RESPONSE TO HCGS SER OPEN ITEM 3
HOPE CREEK GENERATING STATION
DOCKET NO. 50-354

PSE&G RESPONSES TO NRC REQUEST FOR
ADDITIONAL INFORMATION NUMBER 1 (RAI-1)
REGARDING THE HOPE CREEK GENERATING STATION
PRE-SERVICE INSPECTION PROGRAM

ATTACHMENT 2
PAGE 1 OF 3

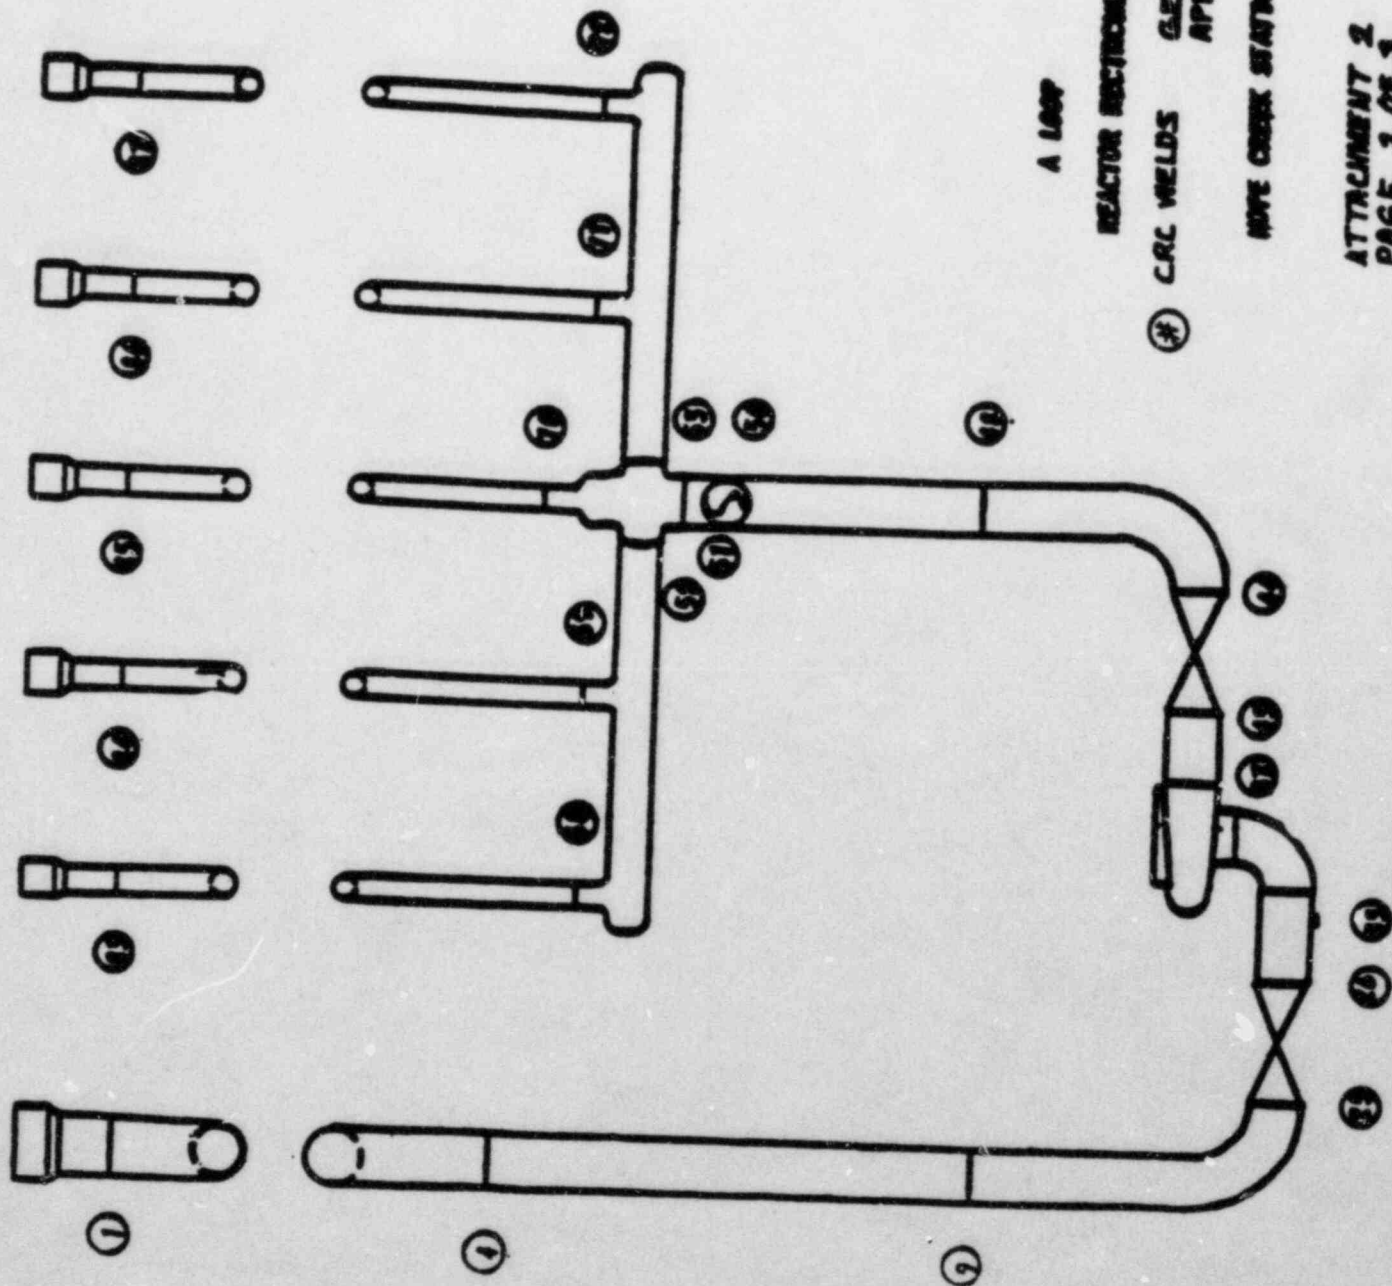
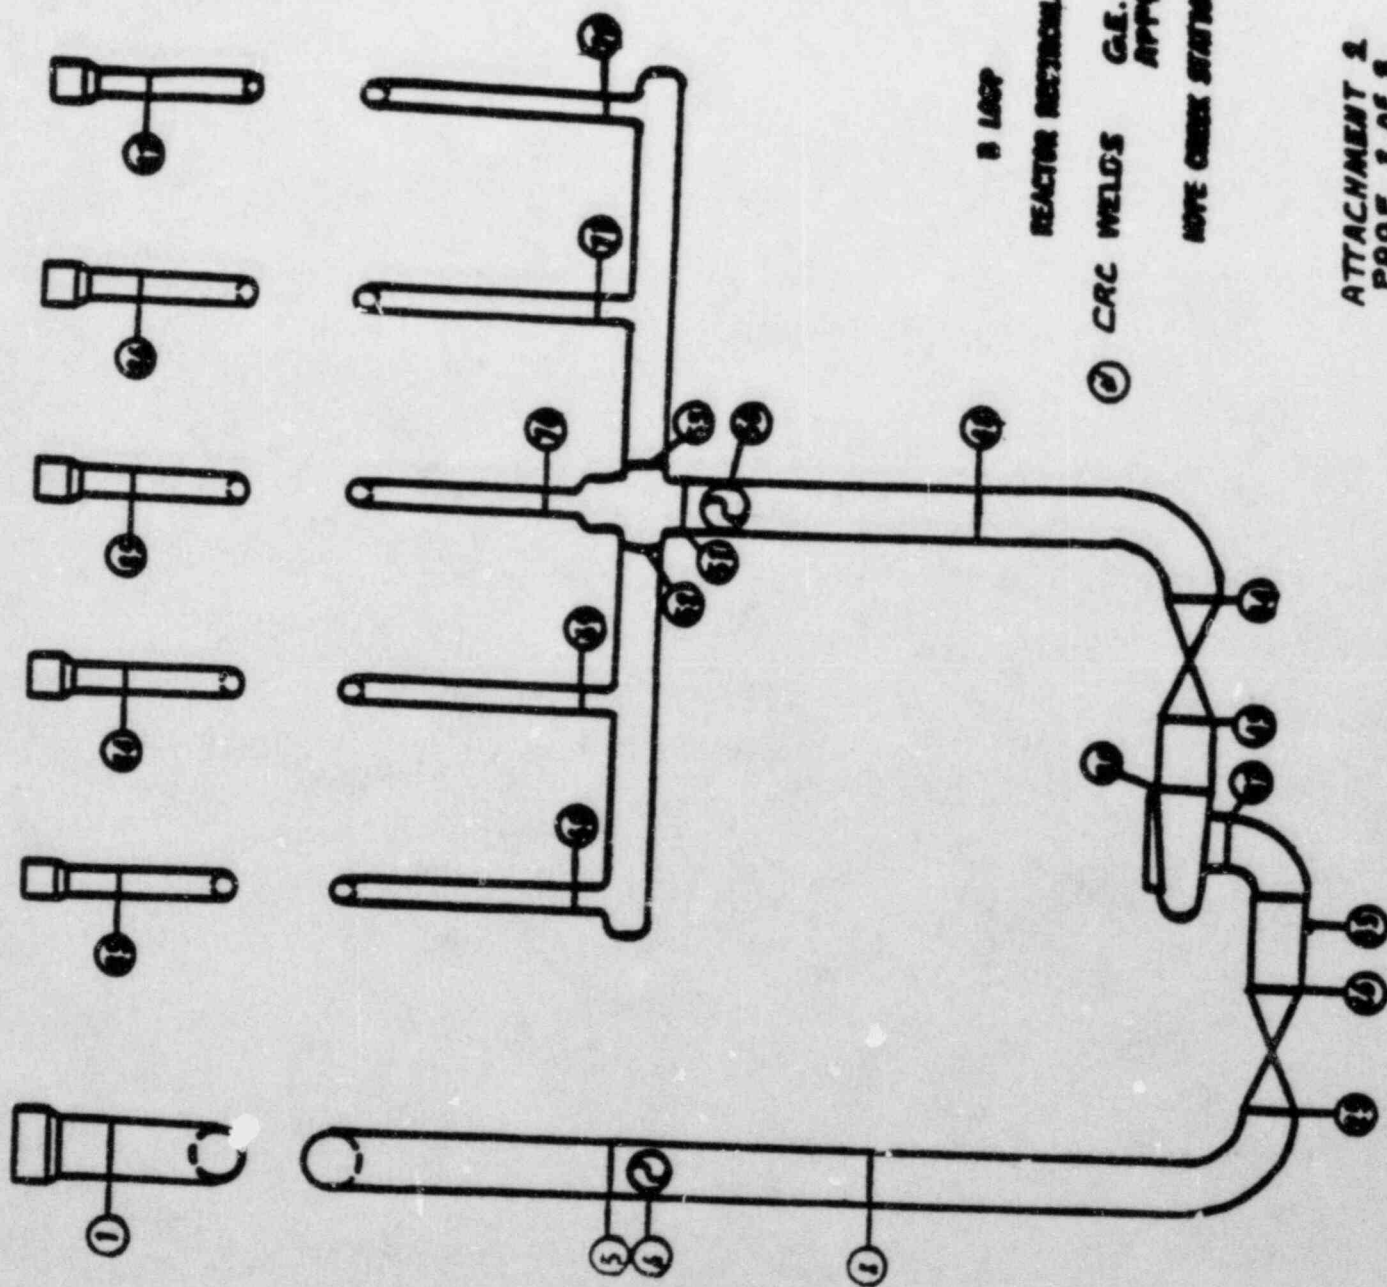
The staff review of the PSI plan indicates that the use of cladding on piping welds may interfere with effective ultrasonic examination. Plans for qualification of the volumetric examination procedure to be used on the subject welds should be discussed. Standard, minimum code radiography may not be capable of detecting service-induced degradation because the detection of cracks is strongly dependent on the angle of the central axis of the radiation beam with respect to the predominant crack plane. If radiography is planned, provide the technical justification, including qualifications and procedure requirements to demonstrate that the radiography procedure is effective for volumetric examinations.

The Applicant should also provide detailed information describing the specific welds with corrosion resistant cladding and typical dimensions of the cladding.

In addition to the information presented by PSE&G on November 26, 1984 (see NRC meeting summary dated December 18, 1984, for details), the NRC requested more detailed information on typical cladding dimensions of CRC weld joints. Attachment 2 shows sketches of the Reactor Recirculation Loop piping Loop A and B and cladding dimensions for various nominal pipe sizes.

CRC WELD

NOMINAL PIPE SIZE	I. D.		WALL THICKNESS		CLADDING O.D.	THICKNESS I. D.
	FINAL MIN.	AS-BUILT MAX.	FINAL MIN.	AS-BUILT MAX.		
28	25.450"	26.477"	1.100"	2.400"*	ESTIMATED 0.19"	APPROXIMATELY 0.25"
22	19.937"	19.994"	1.020"	1.240"	ESTIMATED 0.19"	APPROXIMATELY 0.25"
20	18.360"	18.363"	0.790"	0.880"	ESTIMATED 0.19"	APPROXIMATELY 0.25"
12	11.488"	11.525"	0.599"	0.811"	APPROXIMATELY 0.19"	APPROXIMATELY 0.25"
4	3.865"	3.875"	0.397"	0.537"	ESTIMATED 0.19"	APPROXIMATELY 0.25"
